Addendum to Final Report AO-2010-009: Walter Fletcher FU24, ZK-EUF
loss of control on take-off and impact with terrain,
Fox Glacier aerodrome, South Westland, 4 September 2010

Addendum to Final Report

Aviation inquiry 10-009
Walter Fletcher FU24, ZK-EUF
loss of control on take-off and impact with terrain
Fox Glacier aerodrome
South Westland
4 September 2010

Approved for publication: September 2015

Figure 2: Determination of aircraft manoeuvre margin.(Reproduced from Ref. [1])

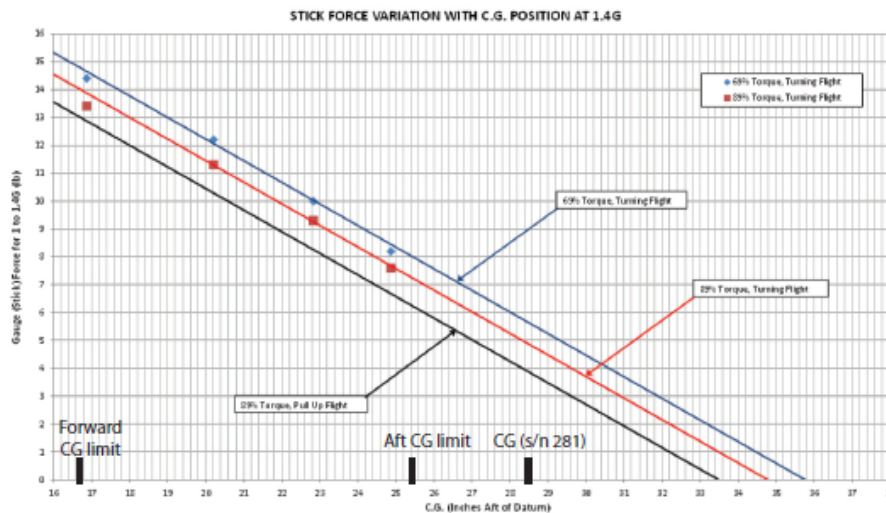
Figure 2 in Reference [1] (replicated and annotated in Figure 2) shows sufficient margin. Although the precision of the data points has been given, the tests are quite transient in nature, so a significant amount of uncertainty exists when taking the measurements.

As acknowledged by the investigators, the data presented in the report effectively demonstrates a spot check has been carried out. Accurate calculation of the MNP requires the investigators to carry out a series of incremental g tests and conducting the corresponding analysis. This is illustrated in Figure 3 that shows the gradient of required elevator angle (η) to normal acceleration (g) at aft and forward centres of gravity are required to obtain MNP (h_m). A similar approach is recommended to obtain stick-free MNP, which will require the measurement of stick force instead of elevator angle.

The analysis also needs to consider that the differences between wind-up turns and symmetric pull-ups is not constant when carried out at the low normal accelerations, as shown in Figure 2.
